Road & Bridge Design Publications

Monthly Update – June 2016

Special Details

POST 3 DETAIL

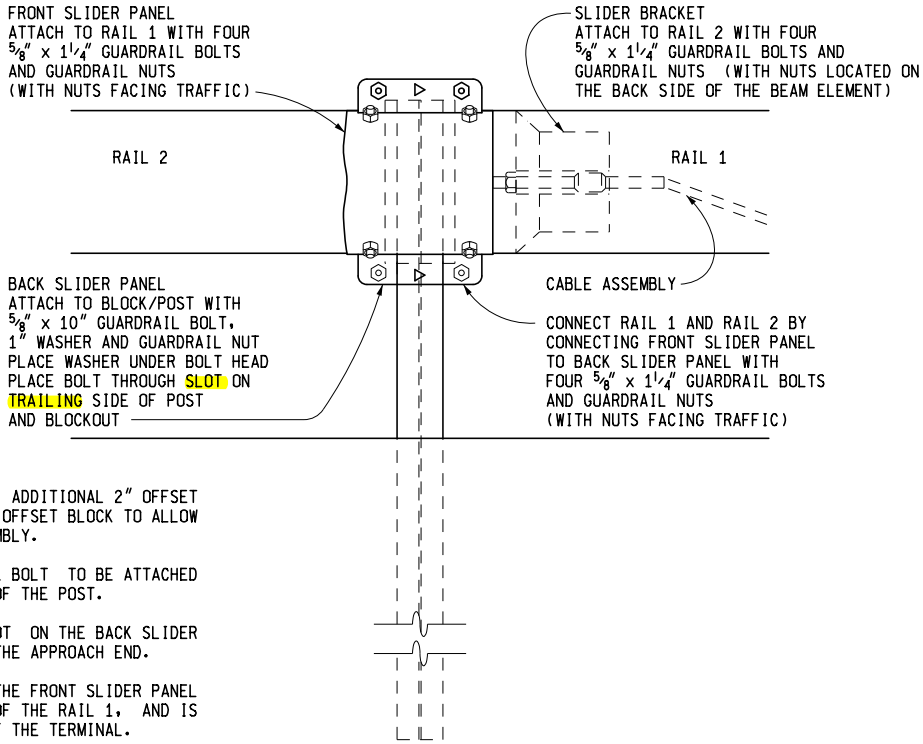
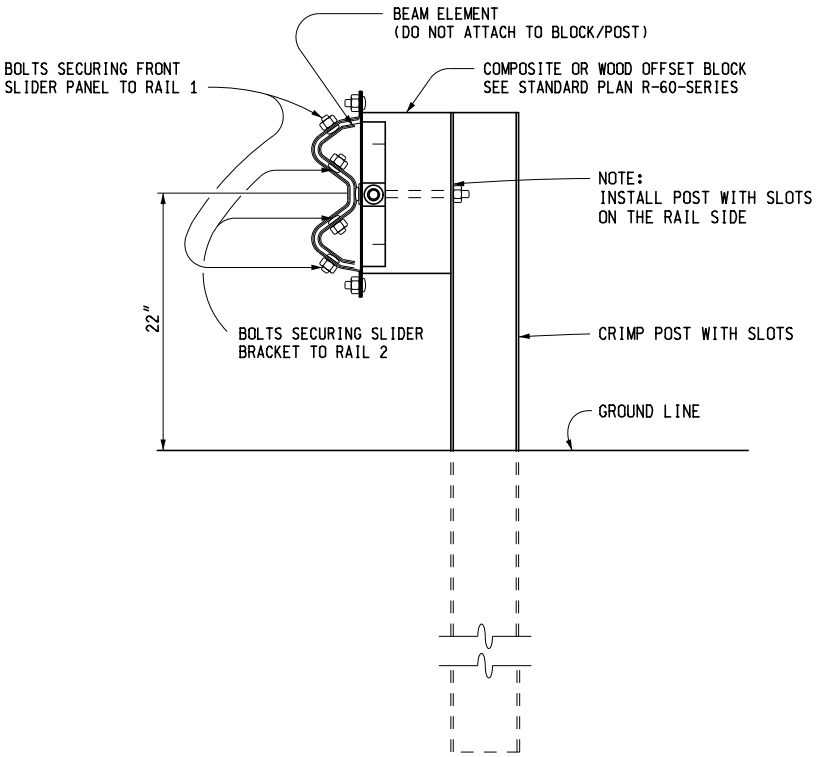
R-61-H: Guardrail Approach Terminal Types 1B & 1T: Revised a few details on the X-Lite Flared Terminal. On sheet sixteen, revised the note on the "Back Slider Panel" such that a slot (instead of a hole) is used to connect to the post on the trailing side (instead of approach side). On sheet seventeen, posts 4, 5, & 6 were revised from standard line posts to "crimp posts" (proprietary).

POST 3 REQUIRES GUARDRAIL BOLT TO BE ATTACHED TO SLOT ON TRAILING SIDE OF THE POST.

ENSURE OPEN END OF THE SLOT ON THE BACK SLIDER PANEL IS POINTING TOWARD THE APPROACH END.
